Marin Country Club Neighborhood Association
Public Comment on the CEQA
Draft Initial Study/Mitigated Negative Declaration
for the proposed
Buck Gulch Falls Creek Restoration and Trail Improvement
Project
at
Ignacio Valley Open Space Preserve
State Clearinghouse (SCH) Number: 2026#####

July 22, 2026

The Marin Country Club Neighborhood Association (MCCNA) conducted an independent technical review of the Draft Initial Study/Mitigated Negative Declaration (IS/MND) for the Buck Gulch Falls Creek Restoration and Trail Improvement Project. The review evaluates whether the Draft IS/MND adequately documents the analytical basis and supporting evidence for its significance determinations under the California Environmental Quality Act (CEQA) Appendix G Environmental Checklist.

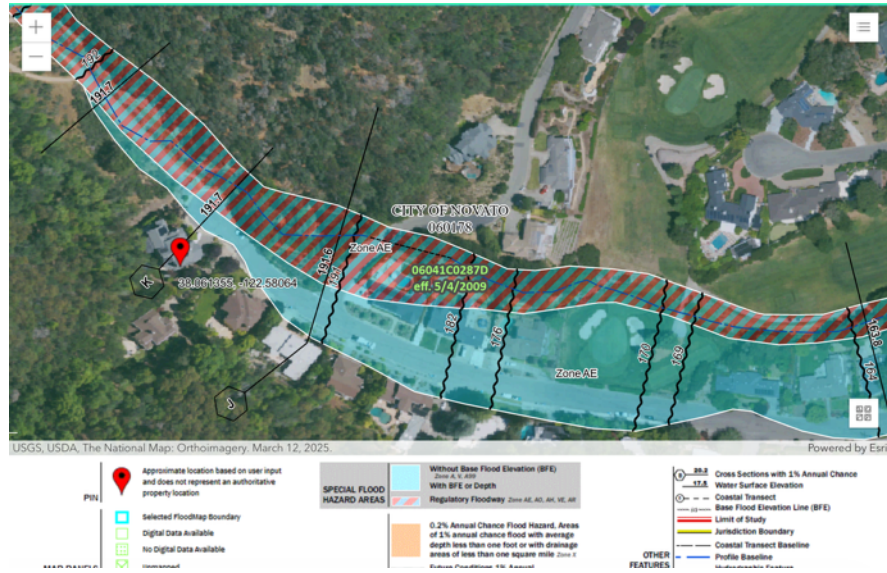
The IS/MND concentrates its flooding narrative almost exclusively on the structural placement of the two large pedestrian bridges. It does not analyze how the *remainder* of the project—the half-mile of linear grading, the individual creek bank rock fill placements, the puncheons and boardwalk, the cut-and-fill balances, and the concentrated runoff from the compacted trail surface—will collectively impact downstream peak flows.

If the project increases peak runoff volumes or restricts active floodway capacity through bank fill and grading within the riparian corridor, it risks increasing the base flood elevation for the Fairway Drive subdivision, placing the project in direct violation of Policy SW.31.

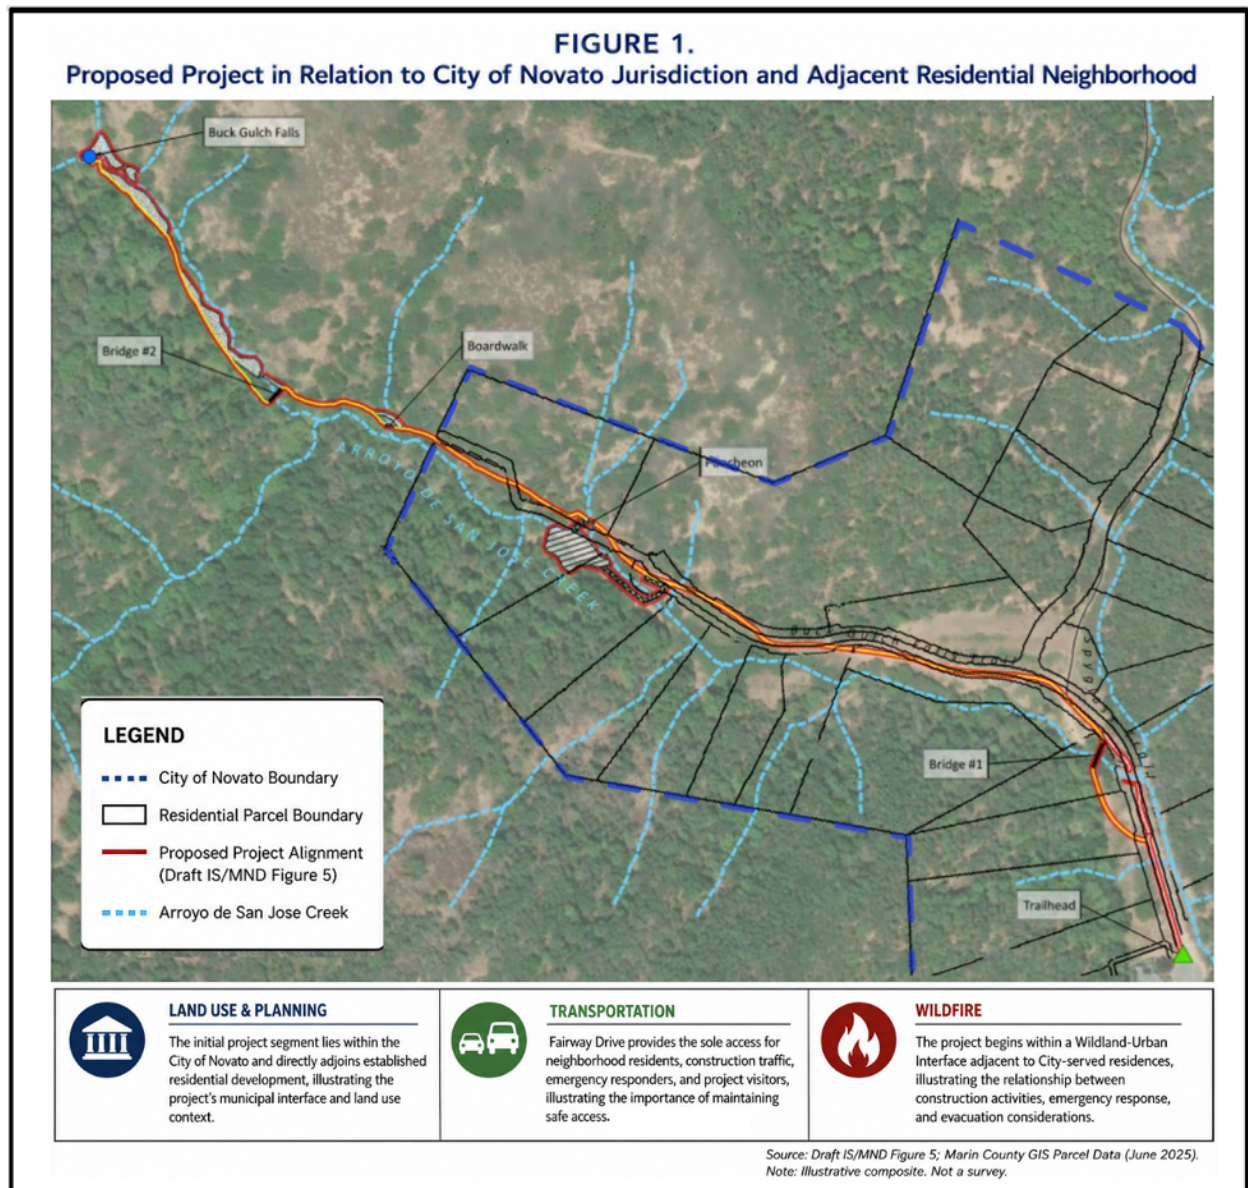
As illustrated in Figure 1, the project begins immediately adjacent to an established residential neighborhood within the City of Novato, where visitor access is dependent upon neighborhood streets serving both residents and project users.

Despite these objectives, the Land Use analysis does not document the basis for concluding that permanent reliance on residential streets for visitor parking is compatible with surrounding residential land uses. It also does not explain how that reliance is consistent with local land use objectives related to neighborhood safety, emergency access, residential access, and street capacity.

As shown in Figure 1, the initial portion of the proposed project lies within the City of Novato before entering County open space. The IS/MND identifies a City of Novato Encroachment Permit as the only required City discretionary approval while describing a project consisting of two

As illustrated in Figure 1, the project site is located at the end of a 2-mile, single-access road that serves as the sole route for residents, emergency responders, and visitors. The IS/MND limits its emergency access review to internal trail widths, ignoring the Fairway Drive corridor. It fails to evaluate whether visitor parking spillover constricts the effective width of the road, potentially delaying emergency response or blocking evacuation. There is no documented consultation with the Novato Fire Protection District or City Police regarding the adequacy of turnaround capacities at the terminus.

Figure 1 illustrates that Fairway Drive effectively functions as the project's transportation infrastructure. Because no dedicated visitor parking or drop-off facilities are proposed, this residential roadway serves as the project's permanent visitor access route, parking area, construction haul route, emergency access corridor, evacuation route, and accessible approach to

As illustrated in Figure 1, the project begins adjacent to residential neighborhoods and is accessed through the Fairway Drive cul-de-sac, where emergency access, evacuation capacity, and responder safety are critical wildfire planning considerations.

Figure 1 illustrates the project's immediate interface with adjacent residential development and provides context for the area's ongoing wildfire mitigation efforts, including regional fuel management programs intended to reduce community wildfire exposure.
